STATE OF NEW YORK : COUNTY OF ORANGE  
TOWN OF NEWBURGH PLANNING BOARD

CUMBERLAND FARMS  
(2016-05)

INITIAL APPEARANCE  
SITE PLAN & LOT LINE CONSOLIDATION

**TOWN OF NEWBURGH  
PLANNING BOARD  
TECHNICAL REVIEW COMMENTS**

SHEET TITLE: SITE PLAN

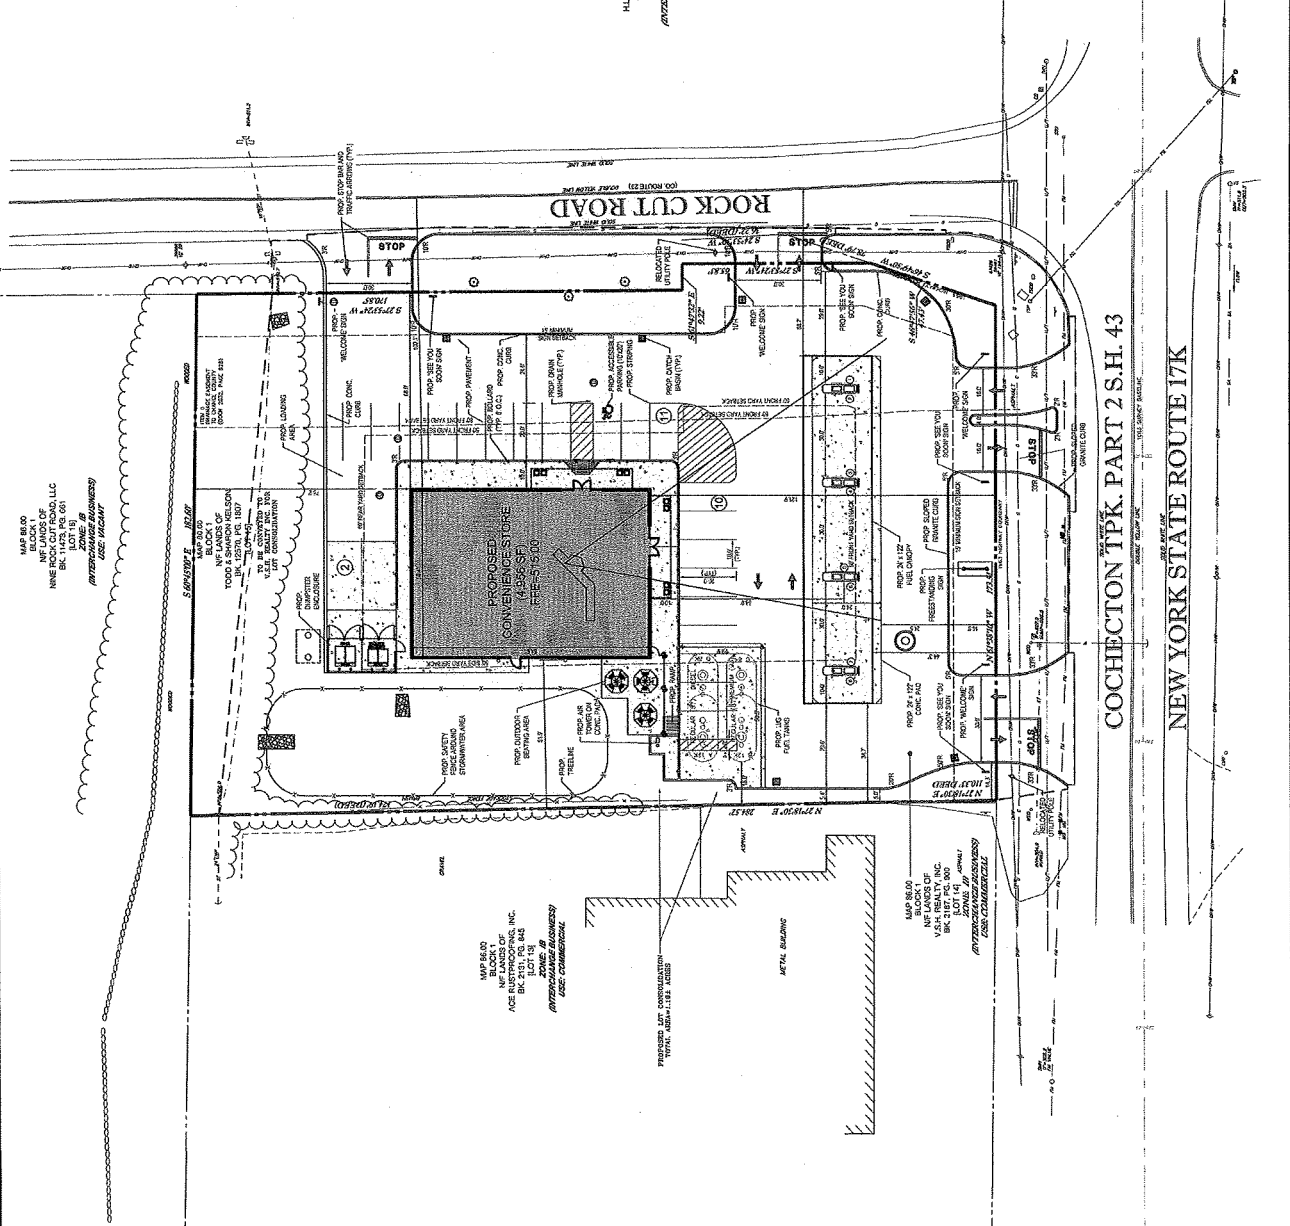
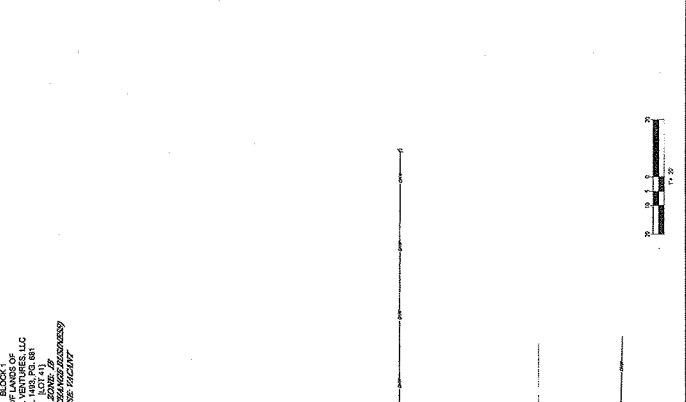
12. Based on a review of the plans the following variances will be required:
  - a) Maximum Canopy Height
  - b) Front Yard Setback for Canopy from both Rock Cut Road & Rt. 17K

- c) Front Yard Landscaping Requirement
  - d) Signage Locations in Front Yard
  - e) Side Yard for Canopy
  - f) Number of Required Parking Spaces
13. Notes on the Demolition Plan should be added requiring a demolition permit from the Town of Newburgh Building Department for removal of any and all structures. In addition a permit is required for removal of existing petroleum bulk storage tanks.

14. Parking spaces are depicted as 10x20. Town of Newburgh parking spaces are 9x19 with a double stripe pattern. Striping pattern details should be added to the plans.

SHEET TITLE:  
**GRADING & DRAINAGE PLAN**

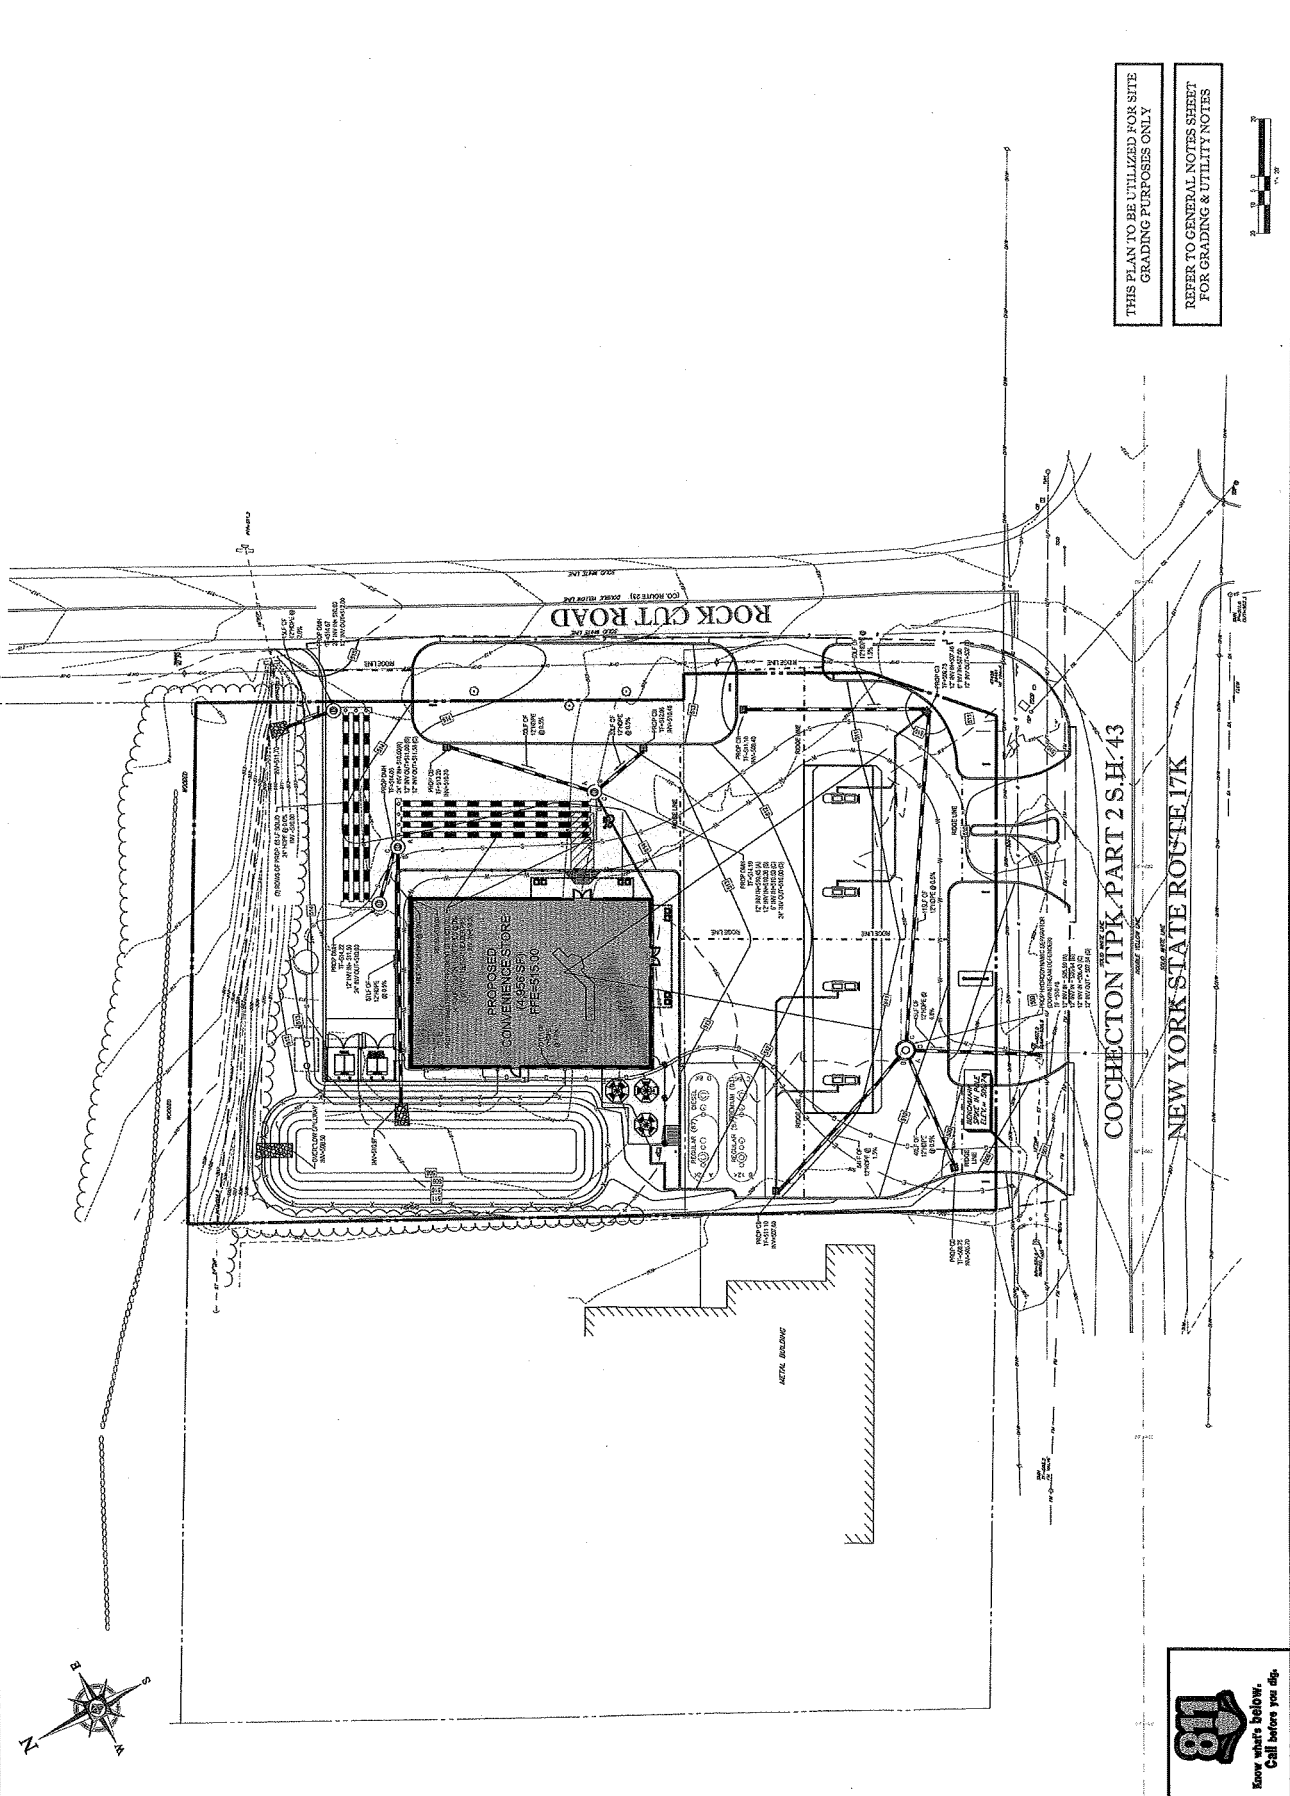
17. A temporary sediment trap is identified in the DOT right of way. This should be addressed with the DOT during permitting.
18. Drainage Plan identifies "ridgelines" on the site. These appear to conflict with the proposed grading. Discharge to the State Highway will occur based on the proposed grading.

**UTILITY PLAN**

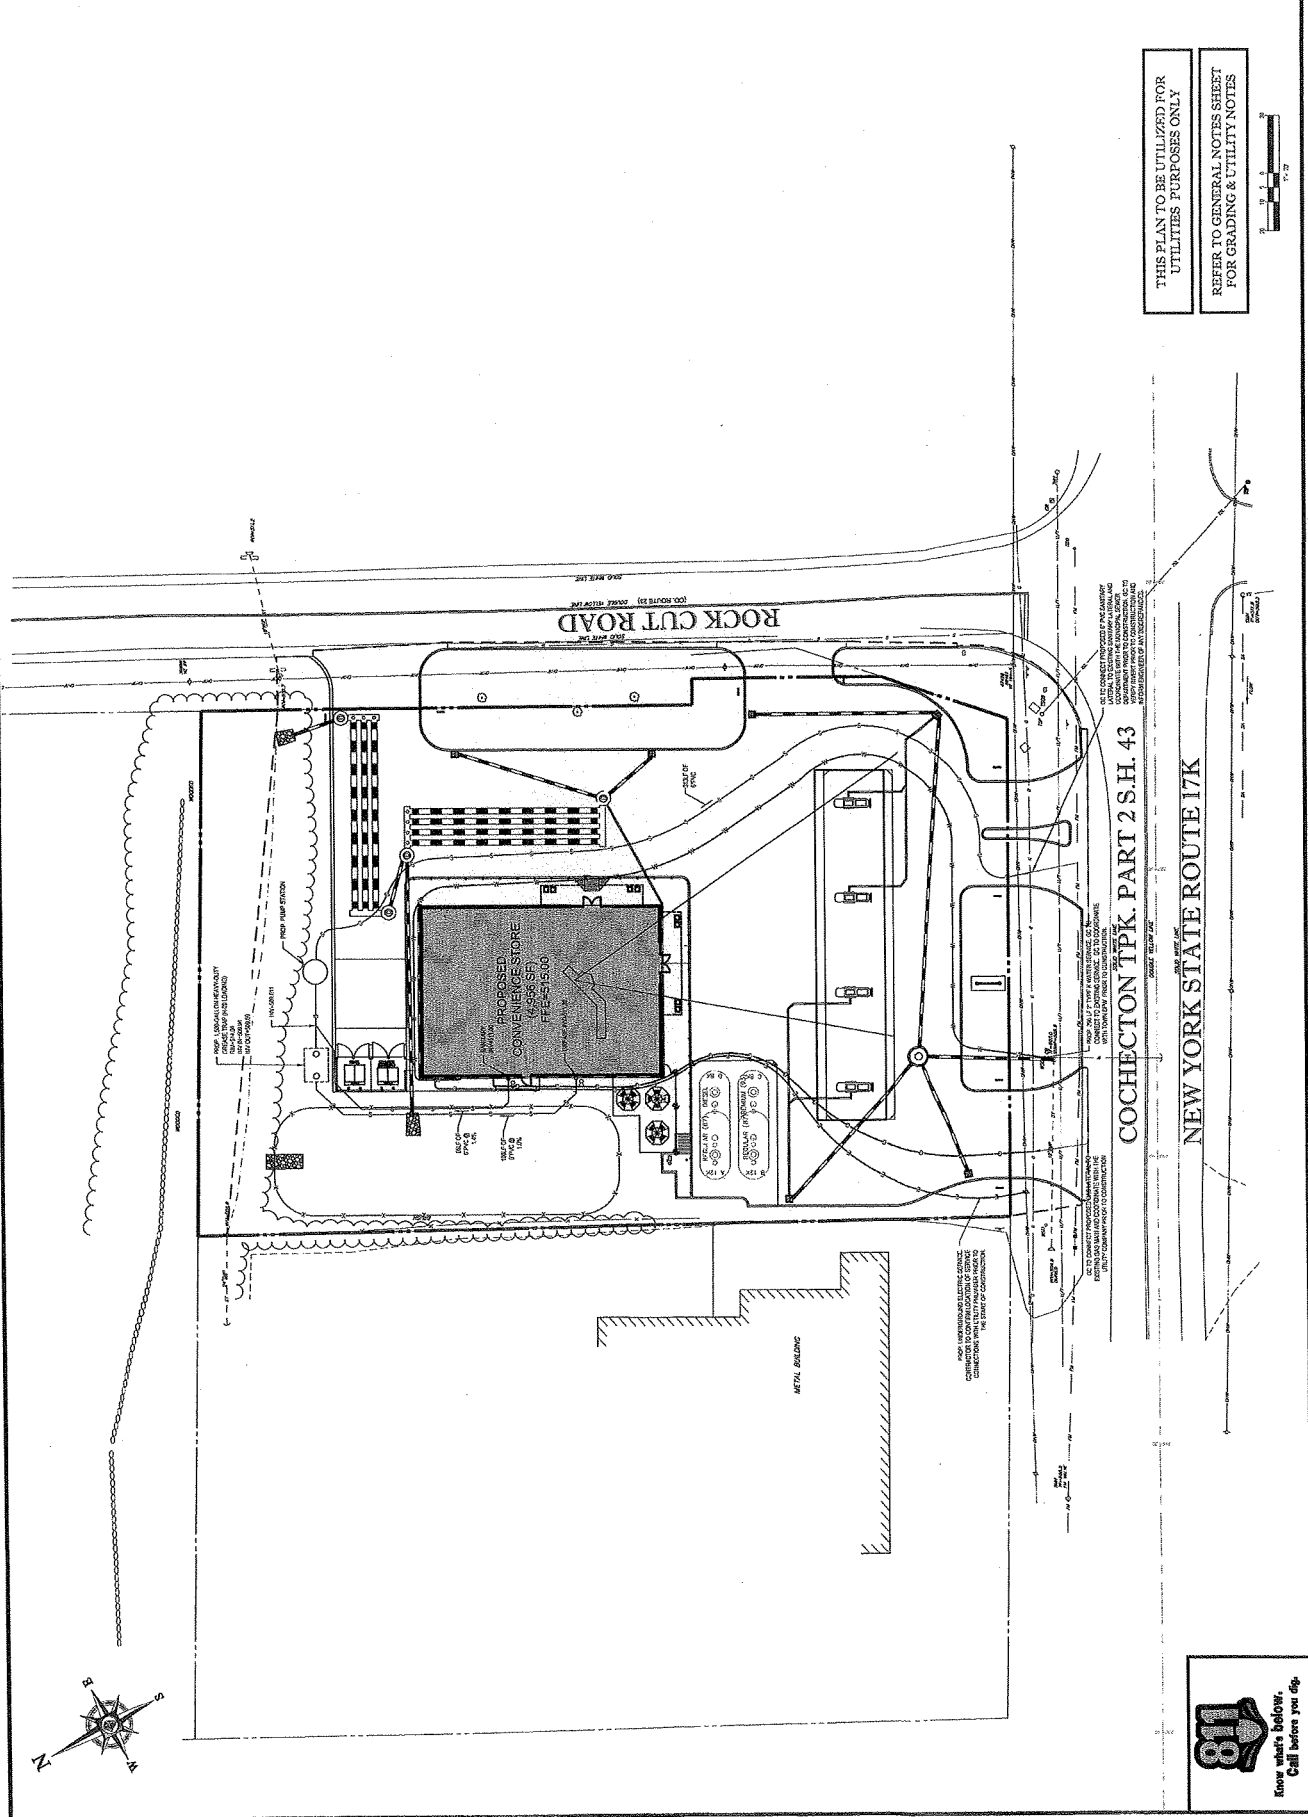
You show 12-inch pipe. The Town standard requires on site plans 15 inch. Those will have to be upgraded.
